**CITY OF FREDERICKSBURG  
HISTORIC REVIEW BOARD**

**TUESDAY, FEBRUARY 14, 2023**

**6. CERTIFICATE OF APPROPRIATENESS APPLICATIONS  
CONSENT AGENDA**

**Historic Review Board**  
**Application Information**

**409 E. MAIN STREET DEV.**  
HRB ELEVATIONS

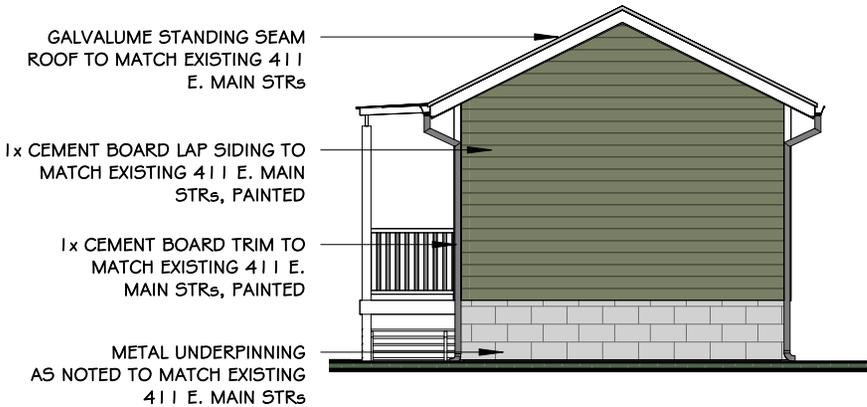
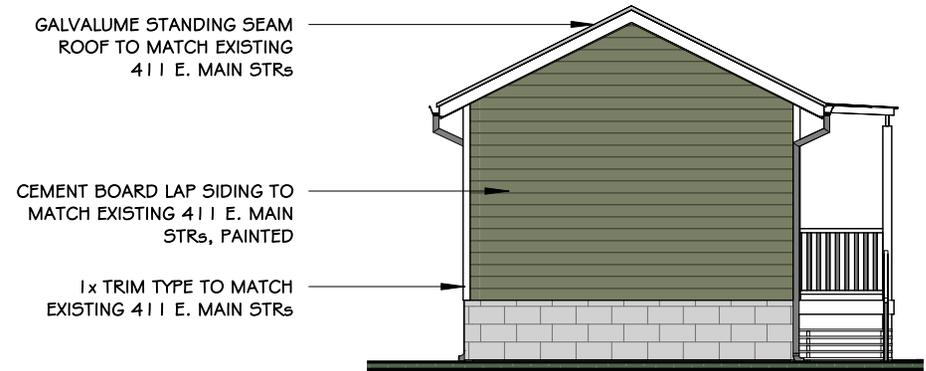
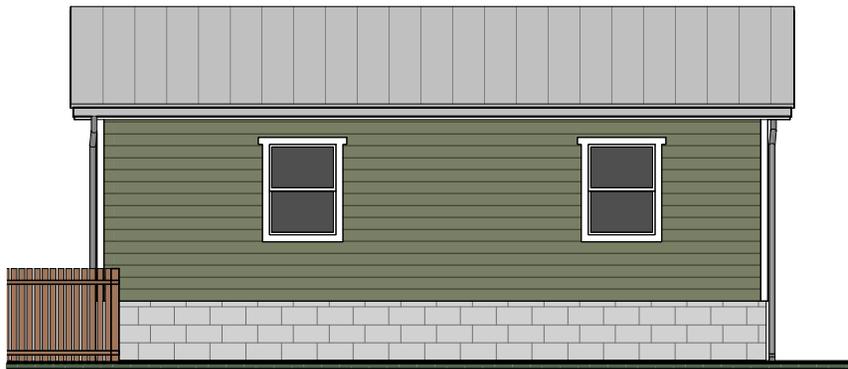
- A. The property has a low rating. The structures in question are not of historic age or integrity. Staff recommend approval of the demolition.
- B. The proposed new construction is to be located behind the existing commercial store front. The casitas will match the already constructed casitas at 411 E. Main. The new will be pushed back further on the lot and should be less visible than those at 411. Staff recommends no more than 3 colors be used for the new construction.
- C. The pavilion will not be readily visible given its location on the lot.
